# UNITED STATES PATENT AND TRADEMARK OFFICE

APPLICATION NO.	FILING DATE	FIRST NAMED INVENTOR	ATTORNEY DOCKET NO.	CONFIRMATION NO.
10/811,372	03/26/2004	George T. Domizio	03-284-2	2082

**Office Action Summary**

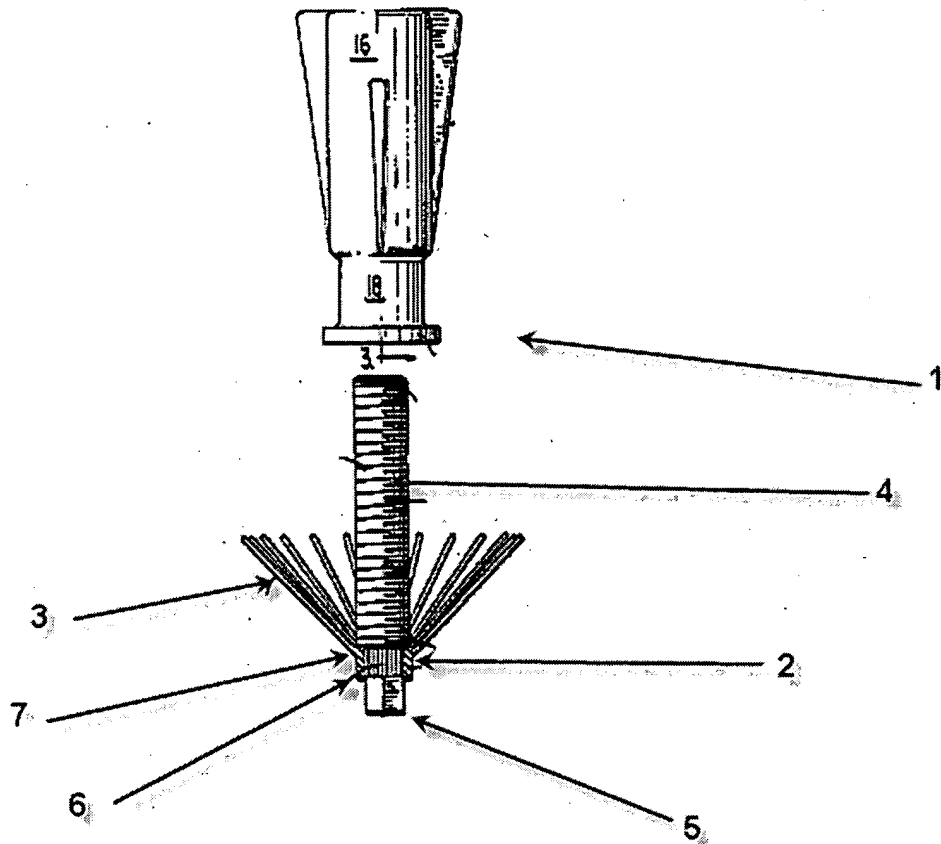
As for Claim 1, Regan et al. discloses a bolt (1) (see figure below) for securing a threaded member relative to a mold wall, comprising:

a head portion (2) having a central portion, a rounded end extending from one end of the central portion and at least one wing (3) flexibly extending laterally with respect to a longitudinal axis of the central portion; and

a thread protector (4) comprising a threaded member (4) having a head (5), the thread protector (4) being releasably (2 is capable of being released from 4, as they are not integral) connected to the central portion (2).

Examiner's note: the applicant should consider the use of the word "frangible" instead of "being releasably connected to" to help properly delineate the patentable features of the present application from that of the prior art.

The difference between the claim and Regan et al. is that Regan et al. does not expressly disclose that the head (5) has a slot in said head. Haldopoulous discloses a bolt with a head similar to that of Regan et al. In addition, Haldopoulous further teaches of the head possessing a slot as shown in figure 3 of Haldopoulous. It would have been obvious to one of ordinary skill in the art, having the disclosures of Regan et al. and Haldopoulous before him at the time the invention was made, to modify the head of Regan et al. to also include a slot, as in Haldopoulous. One would have been motivated to make such a combination because modifying the head by incorporating a slot, allows for a different method by which to remove the bolt, as

with a screwdriver, as taught by Haldopoulos (col. 3, lines 29-30). Since Regan et al., individually discloses of a tool engaging element (5), it is purely a matter of art recognized equivalent and obvious to one skilled in the art to substitute and/or add a slot into the tool engaging element (5) as to allow a screwdriver as one of plural methods by which to remove the bolt.

Re: Claim 2, Regan et al. discloses wherein the central portion has a solid base (6) at an end opposite to the rounded end, and wherein the slotted head (5 in view of Haldopoulos) of the thread protector (4) is releasably (2 is capable of being released from 4, as they are not integral) (also see examiner's note from above) connected to the solid base (6).

Re: Claim 3, Regan et al. discloses wherein the at least one wing (3) comprises at least two wings extending laterally from opposite sides of the central portion.

Re: Claim 6, Regan et al. discloses wherein the at least one wing (3) extends outwardly and rearwardly from the rounded head.

As for Claim 7, Regan et al. discloses wherein the at least one wing (3) is hingedly mounted to the central portion at a hinged connection (7).

Re: Claim 15, Regan et al. discloses wherein the head portion (5) has an axis and the central portion has a side wall substantially parallel to the axis, wherein the at least one wing (3) is pivotable relative to the central portion between a compressed position wherein the at least one wing (3) is substantially parallel to the side wall (Fig. 4) and an extended position (Figs. 5-6) wherein the at least one wing (3) is angled away from the side wall and wherein the outer wall of the at least one wing (3) is aligned with an outer wall of the solid base when the at least one wing (3) is in the compressed position.
